**TOWN OF PURCELLVILLE  
BOARD OF ARCHITECTURAL REVIEW**

April 19, 2016  
7:30 p.m.

**STAFF REPORT**

**TO:** Chairman and Members of the Board of Architectural Review  
**FROM:** Daniel Galindo, AICP  
**RE:** CDA16-03 Southern States  
**DATE:** April 15, 2016

North Elevation

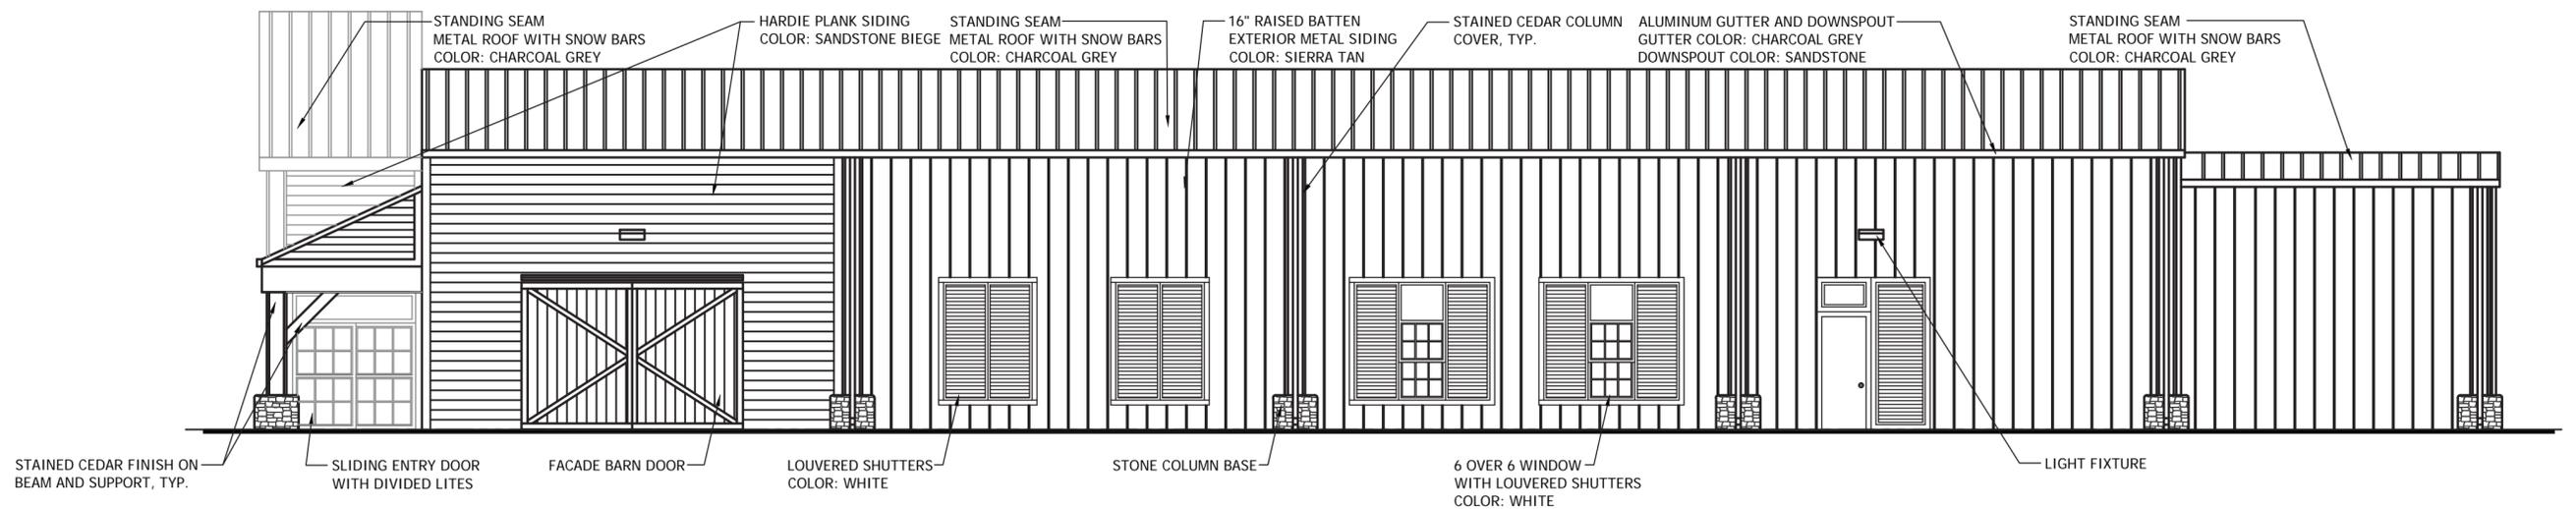
1. On the north (front) elevation:
  - a. The parapet wall has been removed.
  - b. "Sandstone" colored horizontal cementitious siding has been added in lieu of the raised batten pre-finished metal paneling previously proposed.

- c. The stucco previously proposed for the reverse gable has also been replaced with "Sandstone" colored horizontal cementitious siding.
  - d. Black goose neck fixtures are now displayed in the reverse gable for signage.

- e. The amount of windows on the storefront has been reduced, and applied muntins have been added to the storefront windows and doors.
  - f. A stone watertable has been added beneath the storefront windows.

- g. The width of the stone bases around the porch columns have been increased.
  - h. Knee braces have been added.
  - i. The fascia material has been changed from standing seam metal panels to stained cedar boards.

- j. The porch has been continued around the northeast corner to the eastern façade.
2. On the west (side) elevation:
  - a. "Sandstone" colored horizontal cementitious siding is now continued around the corner from the front elevation to the first column, and a faux barn door has been added.

West Elevation

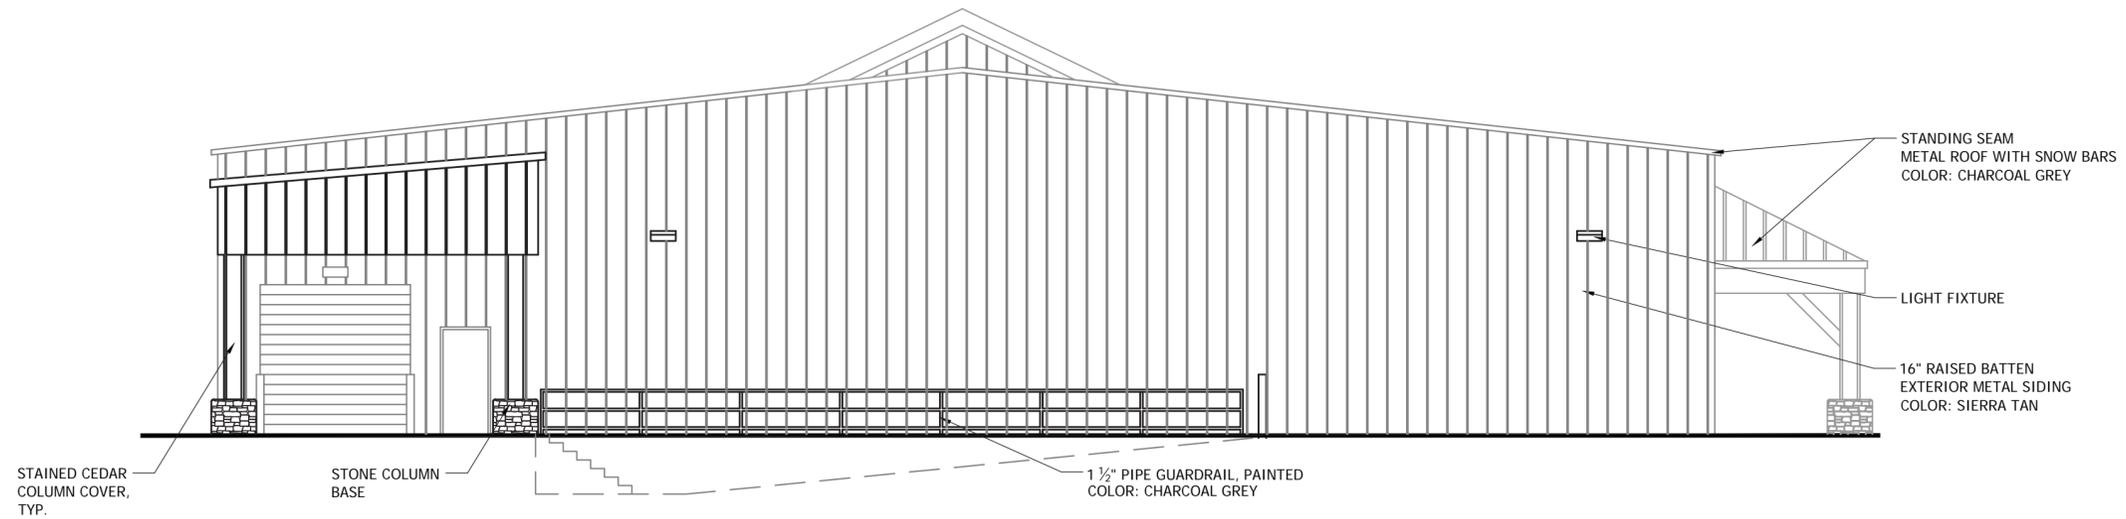
- b. The raised batten pre-finished metal panels used for the remaining bays (and throughout the rest of the building) have increased in width from 12" to 16" and changed in color from "Sandstone" to "Sierra Tan."

- c. The recessed design elements containing horizontal cementitious siding and one over one windows have been removed.
  - d. A pair of white faux shutter-covered windows and a pair of white trim windows with divided lites surrounded by white faux shutter-covered windows now articulate the two central bays instead of the recessed design elements containing horizontal cementitious siding and one over one windows formerly proposed.

- e. A transom window has been added over the service door while a white faux shutter-covered window has been added to its south.
  - f. A cedar and stone wrapped column has been added at the southern termination of the wall.

South Elevation

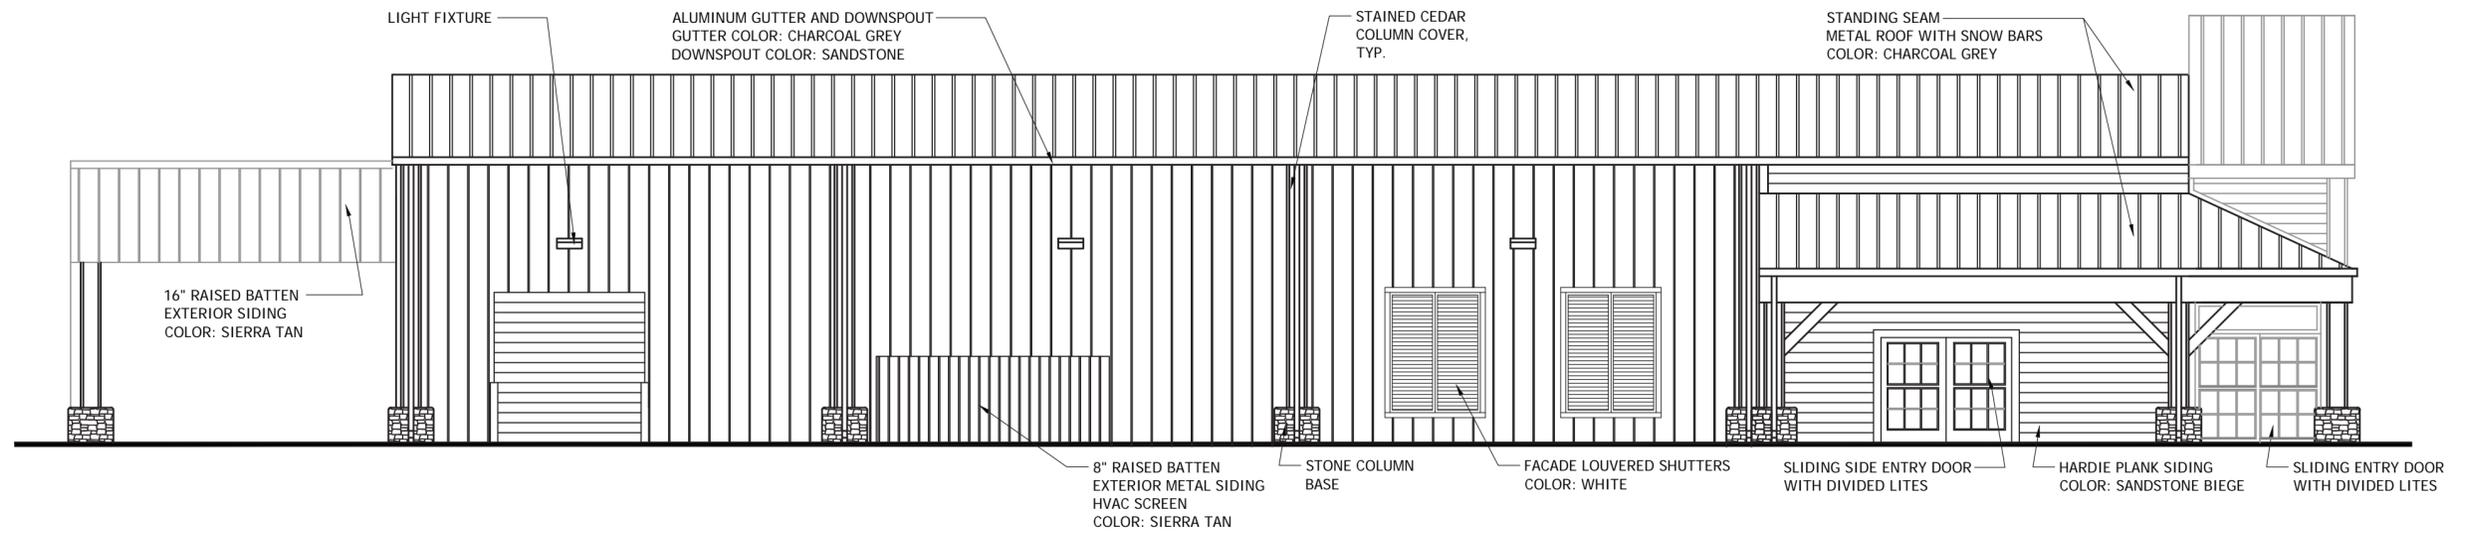
3. On the south (rear) elevation, the columns of the loading dock canopy are now proposed to be wrapped in cedar and stone to match other columns surrounding the building.

East Elevation

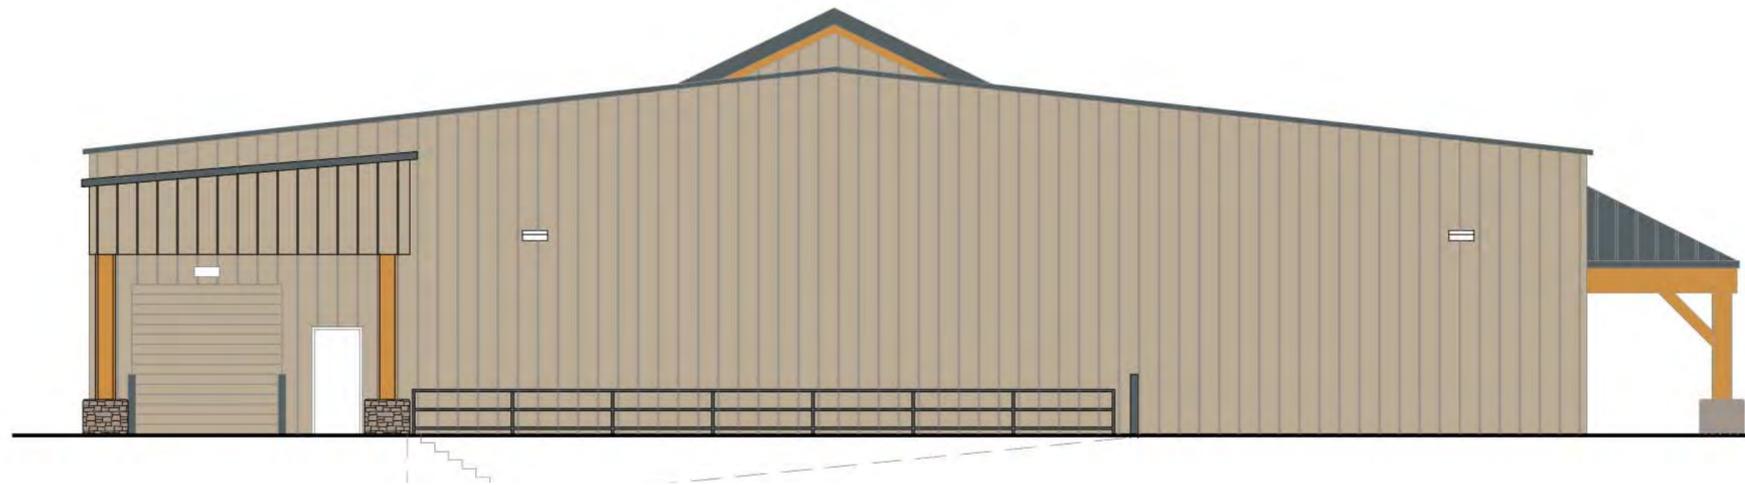
4. On the east (side) elevation:
  - a. "Sandstone" colored horizontal cementitious siding and the porch element are now continued around the corner from the front elevation to the first column.

- b. Applied muntins have been added to the storefront doors.
  - c. The recessed design elements containing horizontal cementitious siding have been removed from the two central bays, and a pair of white faux shutter-covered windows has been added to the northern central bay.
